STAFF REPORT

SUBJECT: FP-2022-0016
Vertex Subdivision No 2 Final Plat

LOCATION: Parcel #S1405120902, located on the south side of E. Lake Hazel Road between S. Locust Grove Road and S. Eagle Road

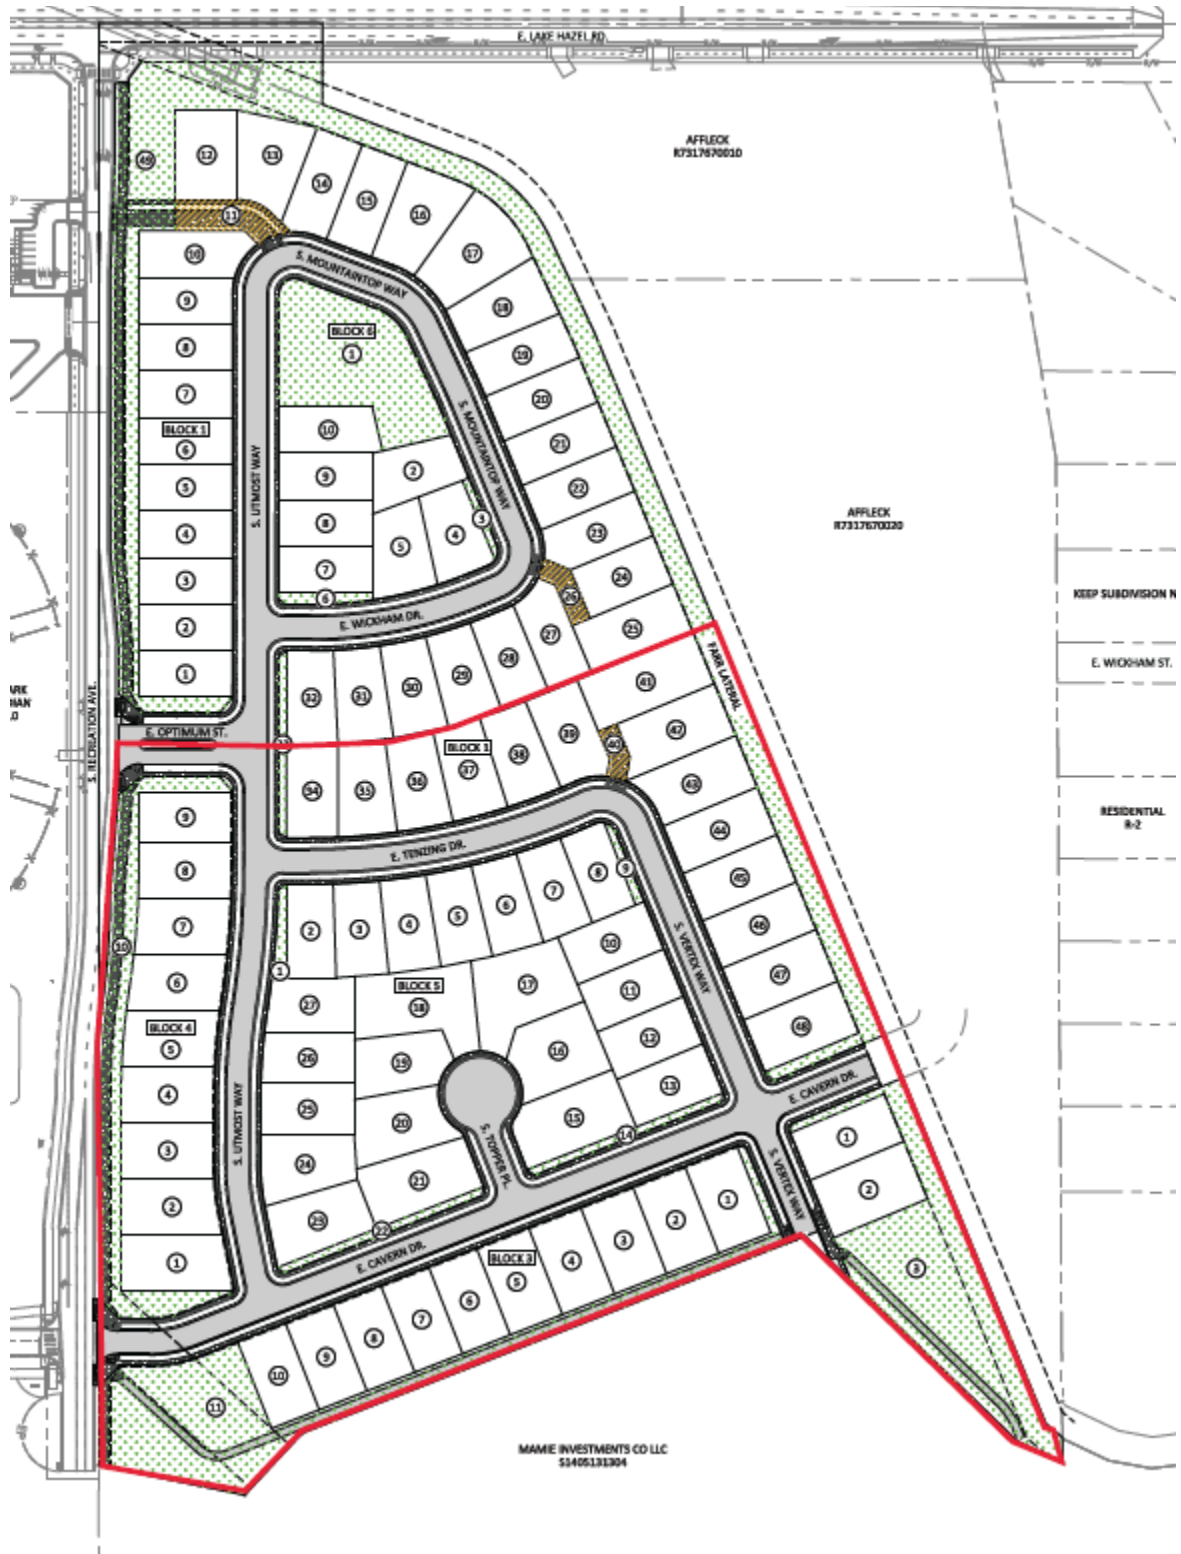
3. Prior to submittal for the City Engineer's signature, have the Certificate of Owners and the accompanying acknowledgement signed and notarized.
4. Revise the notes on the face of the plat prepared by KM Engineering prior to signature on the final plat by the City Engineer, as follows:

- a. Add note referencing development agreement instr. 2022-018711.
 - b. Note #10: Include recorded instrument number.
 - c. Note #11: Include recorded instrument number.

- d. Note #12: Include recorded instrument number
5. The landscape plan prepared by KM Engineering, dated 05/10/2022, is approved as submitted.
6. The City Council waived the requirement to tile the Farr Lateral. All other ditches shall comply with the provisions for irrigation ditches, laterals, canals and/or drainage courses, as set forth in UDC 11-3A-6.
